ASCE 41-17 Tier 1 and Tier 2 Seismic Evaluation Report Rossmoor Buildings:

600 Terra California Drive, Walnut Creek, CA

December 12, 2022

IDA Job No. 22054

DEFICIENCIES AND MITIGATIONS

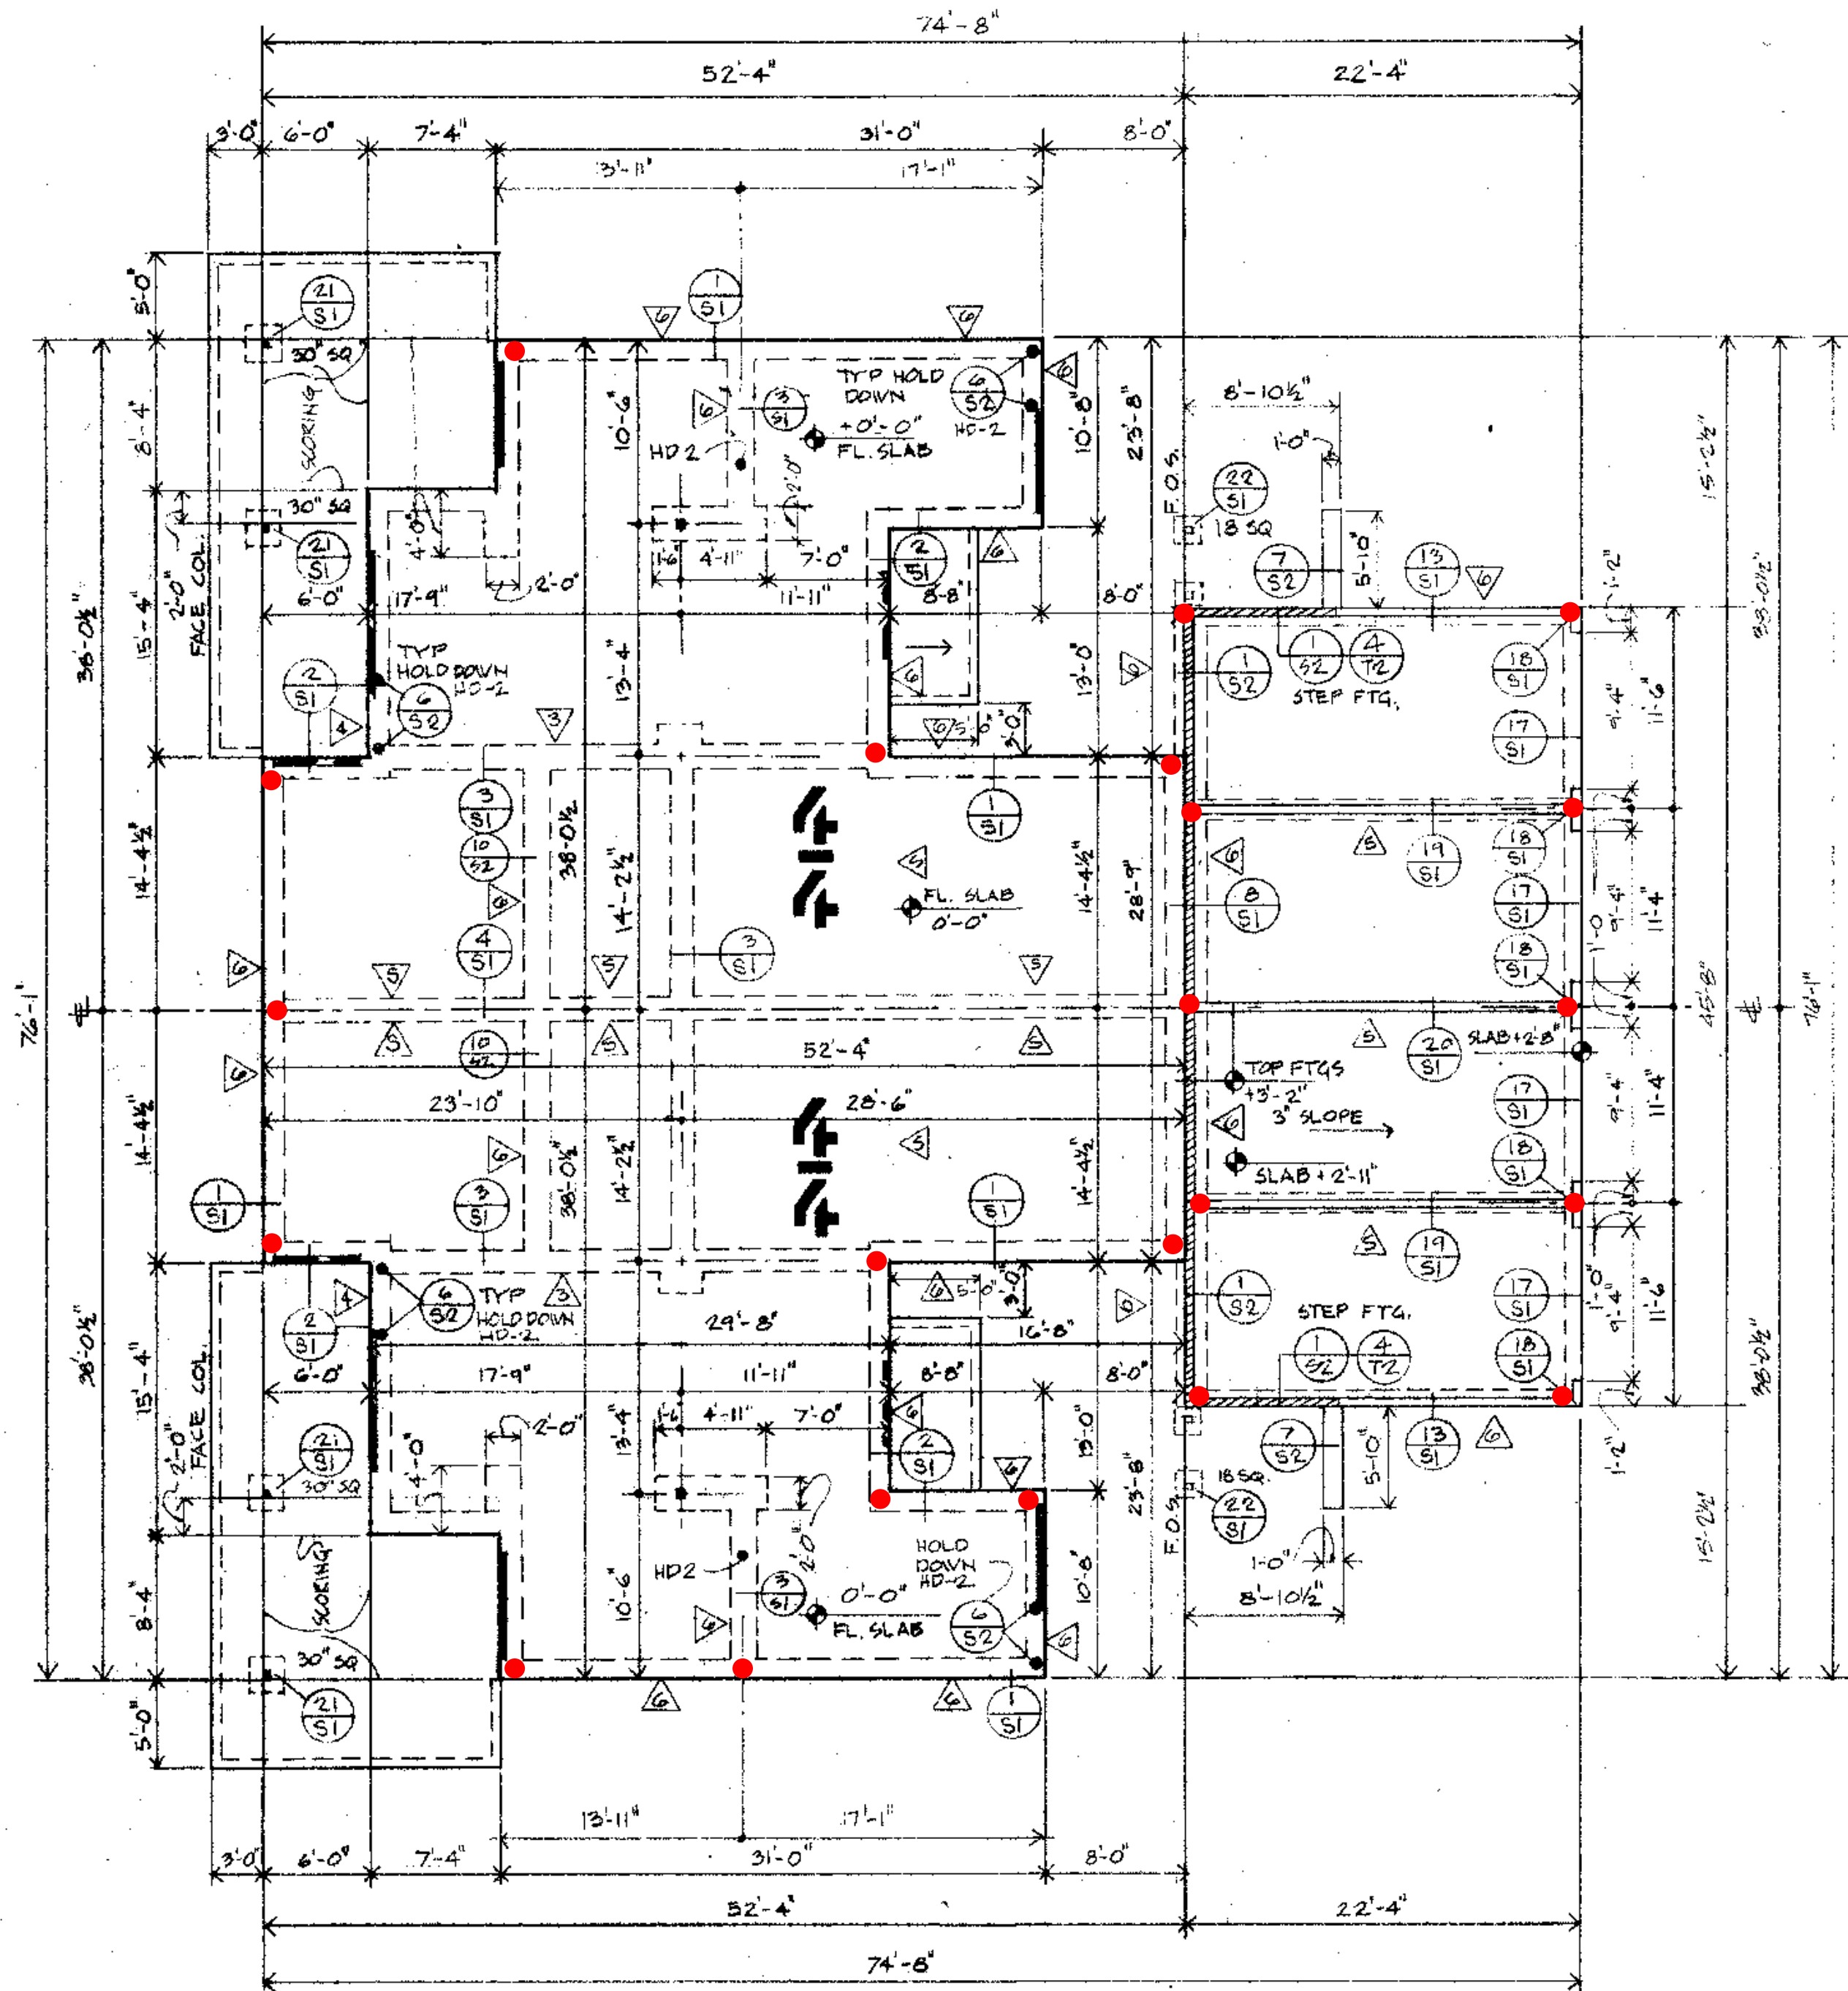
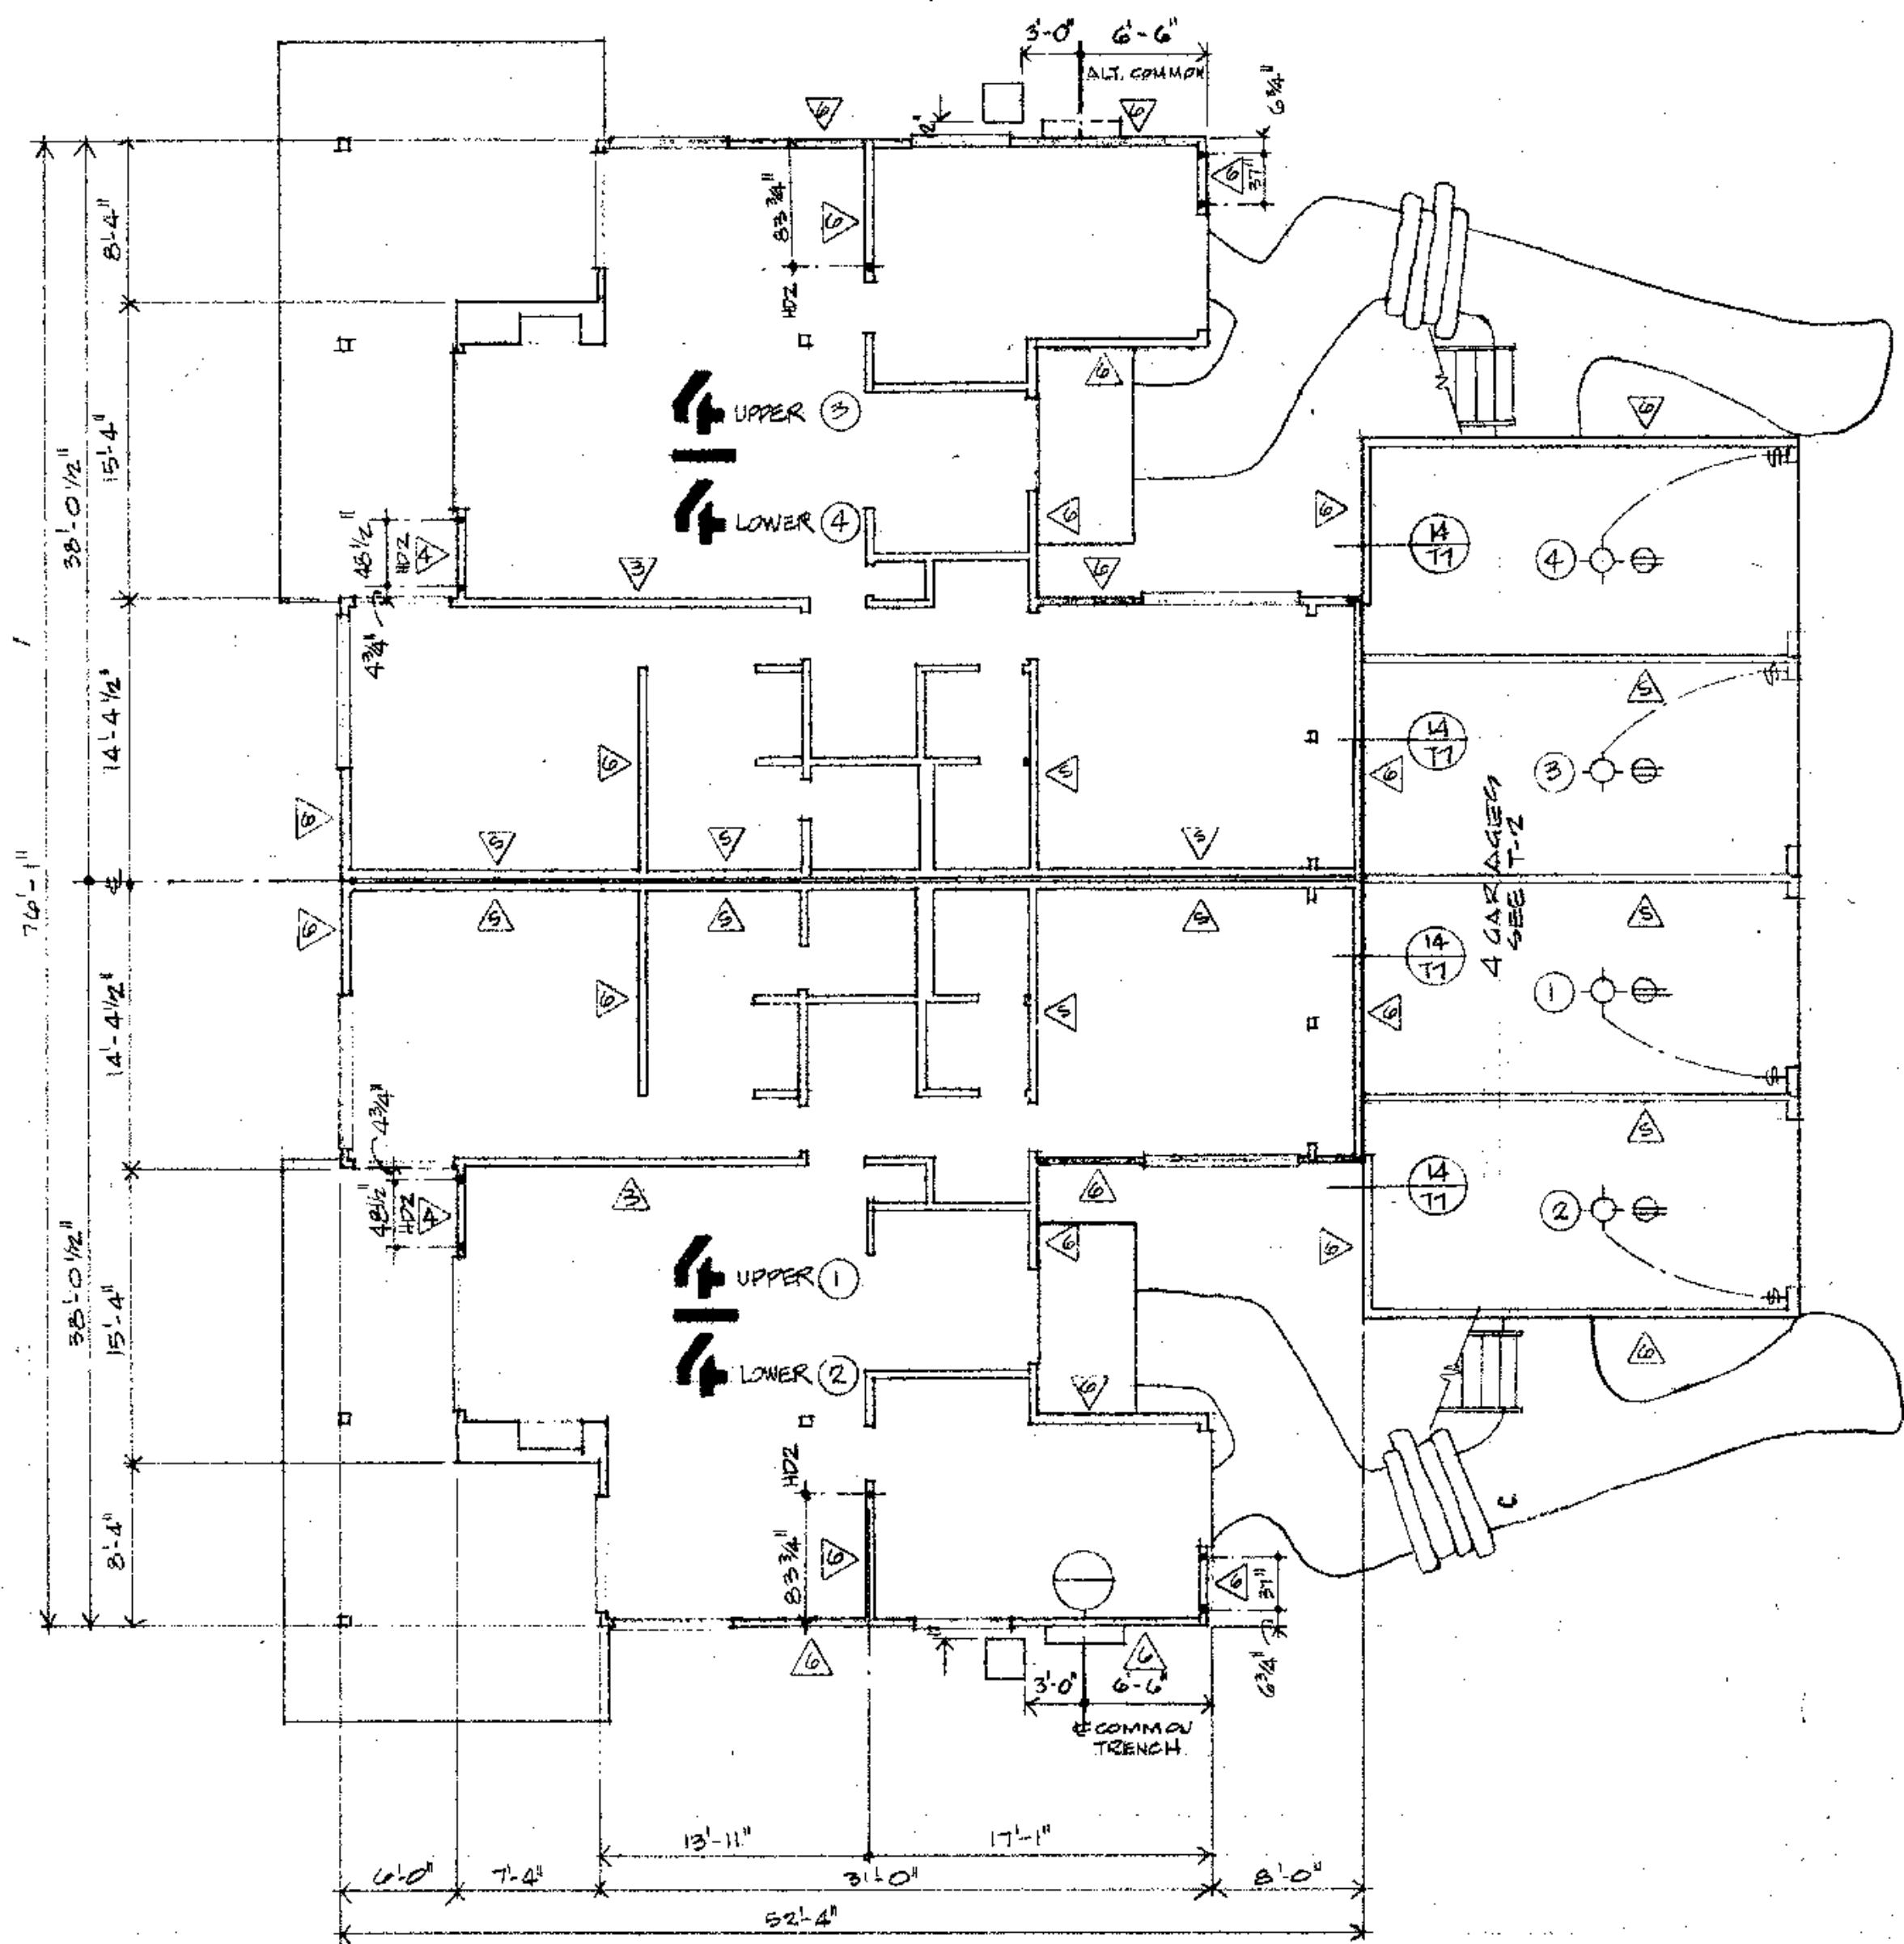
The shear walls do not have interconnection ties to transfer overturning forces through the floor. Shear walls in East-West direction do not have holdowns called out on the plans. Shear walls without holdown anchors may be subjected to significant overturning, and damage can

While the building has holdowns in the transverse loading direction, holdowns appear to be missing in the longitudinal loading direction. In some cases, the original designer of the building may have assumed there was sufficient dead load to resist overturning forces. Lower seismic forces at the time of design may have allowed for this design. However, wood shear

New straps can be added at shear walls to transfer overturning forces between floor to floor. Shear walls without hold downs should be retrofitted with hold down hardware and compression posts. New hold down hardware could be retrofitted at shear wall ends and anchor bolts would need to be epoxied into the existing foundations. Compression posts could be installed along with the hold down hardware as required. Foundation strengthening may be required if existing foundations are shallow or weak in local areas.
